CROSLEY

REVISED MODELS: 11-100U, 11-101U, 11-102U, 11-103U 11-104U, 11-105U

(Chassis 330)

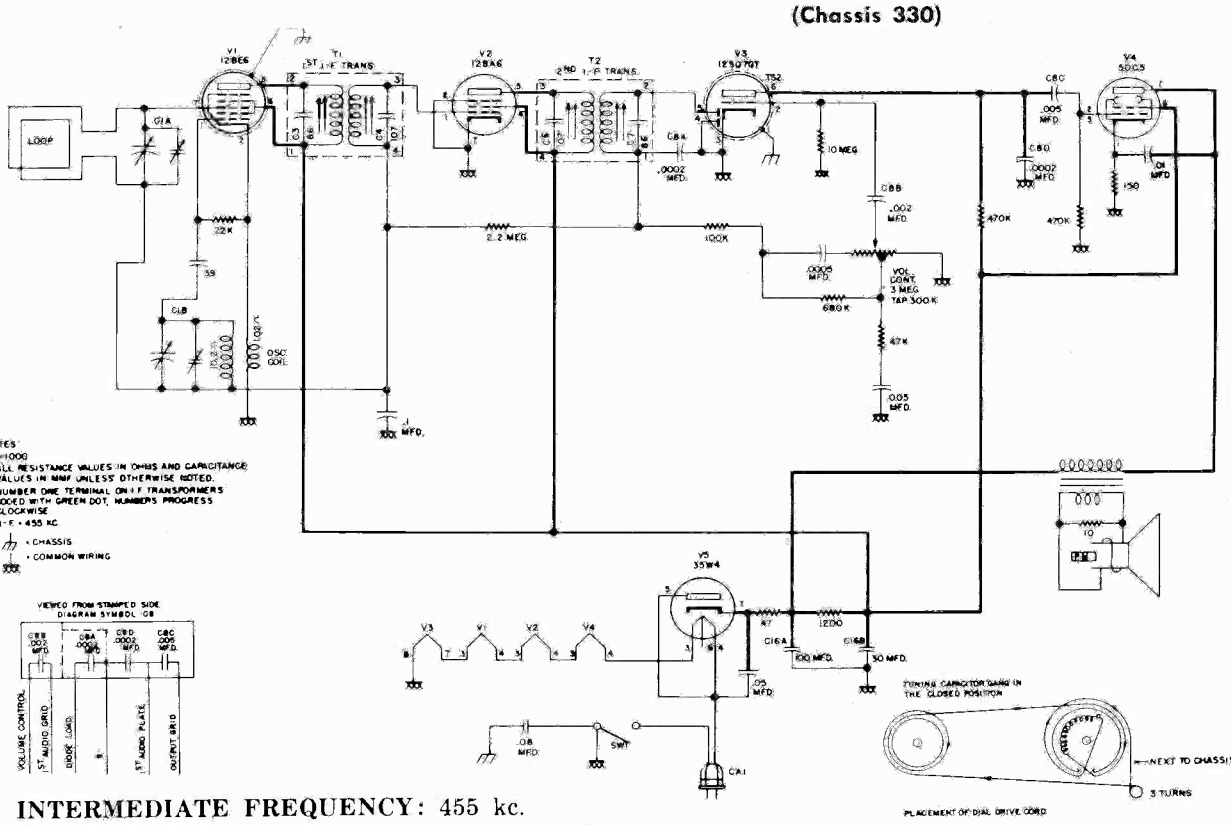
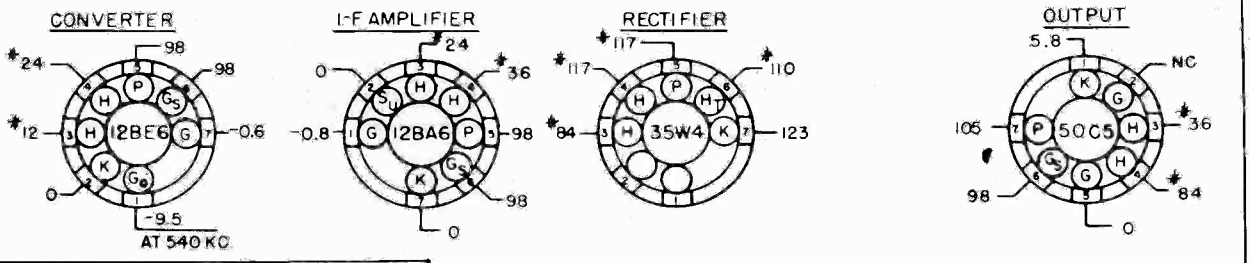
The above listed models also used Chassis 301 which is similar to Chassis 330, but uses 12AV6 instead of 12SQ7 as V3. In some sets R2 is a 3.3 megohms and C5 is .05 mfd.
